PROPERTY DETAILS: 873 Wallaces Gap Road BALLALABA NSW 2622
Lot 81 DP 755905

FILE NO'S: DA.2026.0113

SUBJECT: Referral to Development Engineer for Comments

DESCRIPTION: Construction of a solar farm, battery energy storage systems, landscaping and associated site works

Figure 1: Wallaces Gap Road – Speed Zone

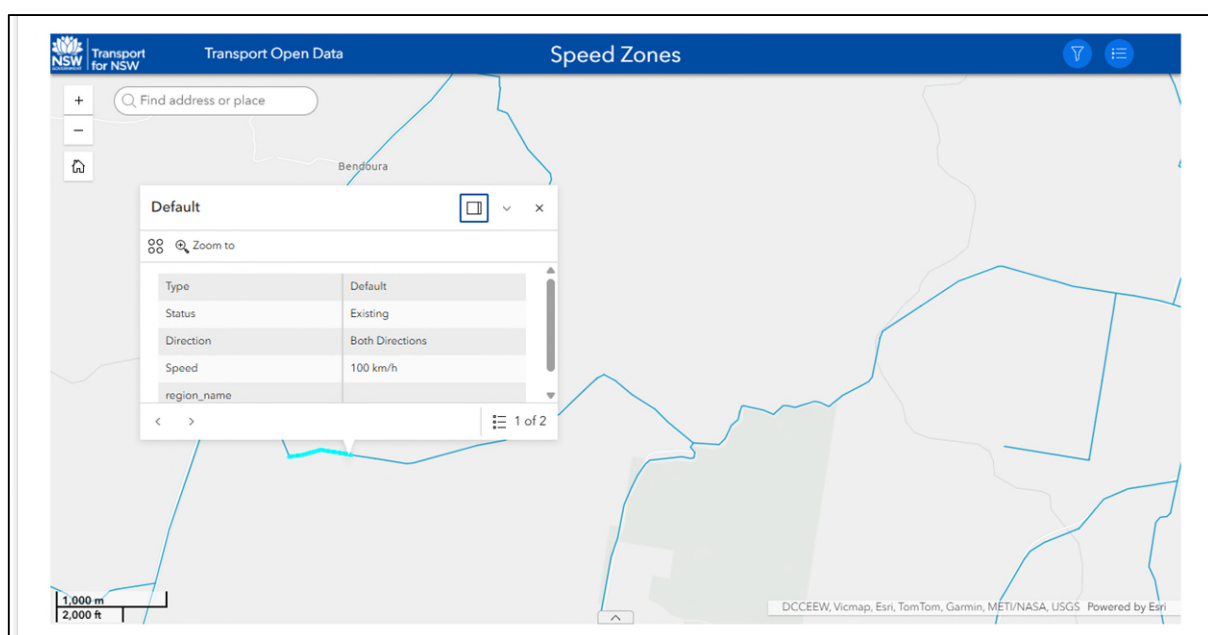
The proposed site at 873 Wallaces Gap Road, Ballalaba, will be accessed via the existing access off Wallaces Gap Road. All construction and delivery vehicles will need to travel approximately 2.8km along Wallaces Gap Road to reach the site. Wallaces Gap Road is an un-signposted rural road with a default speed of 100km/h in accordance with TfNSW Speed Zones data. While 100km/h appears to be an upper limit due to unfavourable road conditions, locals are expected to travel at speeds above 80km/h on large sections of the road.

Figure 2: Intersection Cooma Road and Wallaces Gap Road – Approximate Available Sight Distance

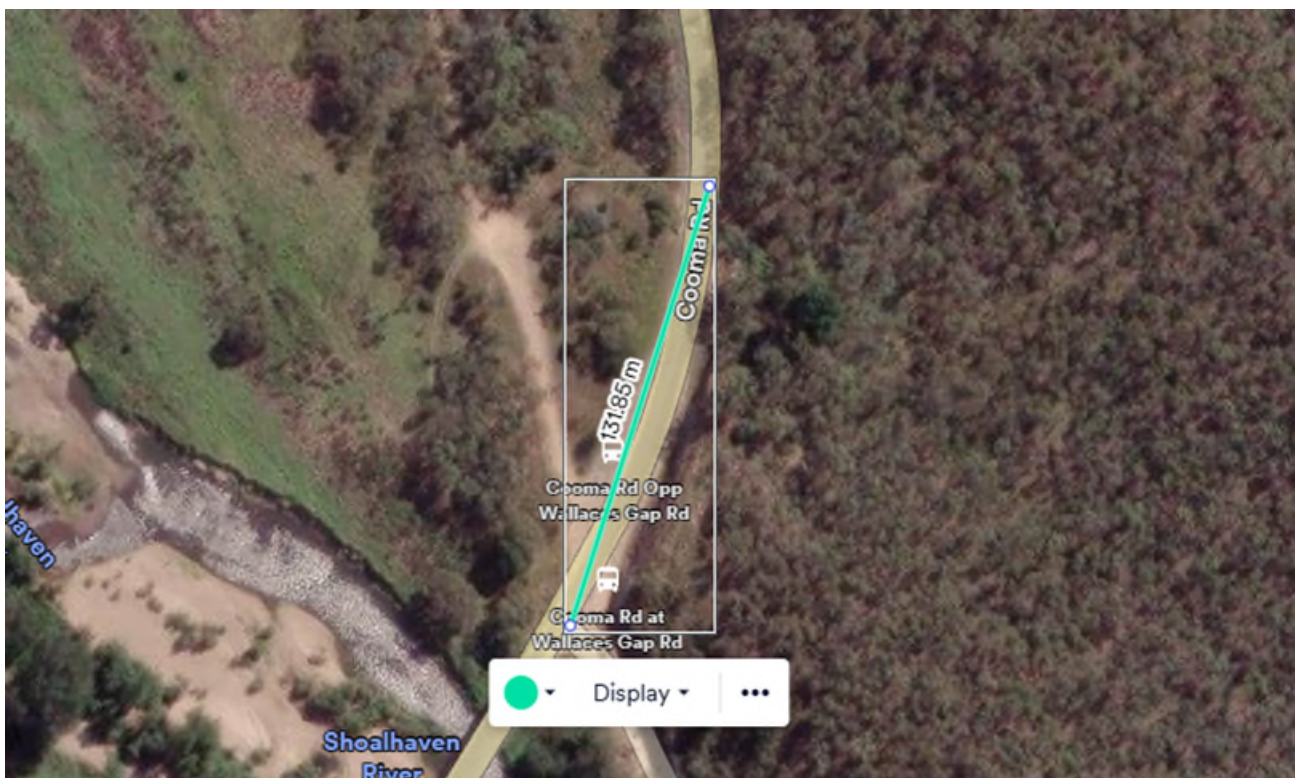
The submitted traffic impact statement has not considered the sight distance available at Wallaces Gap Road and Old Cooma Road.

The proposal would require eight (8) articulated vehicle trips per day and 80 construction vehicle trips per day during construction. This is a significant increase in the number of vehicles that will need to utilise the existing road network, including the intersection. Due to the existing topography of Cooma Road, the available sight distance to the right exiting Walaces Gap Road is less than 130m. This is a considerably shorter sight distance than the required Safe Intersection Sight Distance (SISD) of 296m. The current available sight distance would not be sufficient for the conservative required Stopping Sight Distance (SSD) of 225m as outlined in the Austroads Guide to Road Design Part 4A. As such, development engineering does not support the use of Wallaces Gap and Old Cooma Road intersection for additional vehicles, including articulated vehicles.

Figure 4: Heavy Vehicle Load Distribution

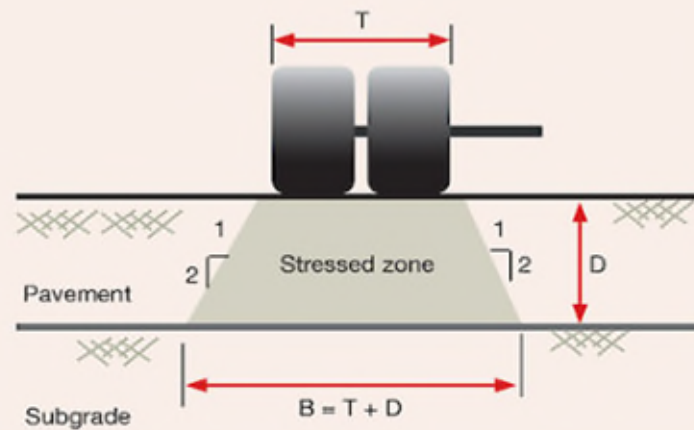
Development engineering also noted during the site visit that sections of road adjacent to the Shoalhaven River have a high erosion risk. The pavement formation on the subject section is narrower, with no shoulder lane to spread the load of heavy vehicles, increasing the risk of road collapse. A detailed slope stability analysis will need to be carried out and included as part of development applications.
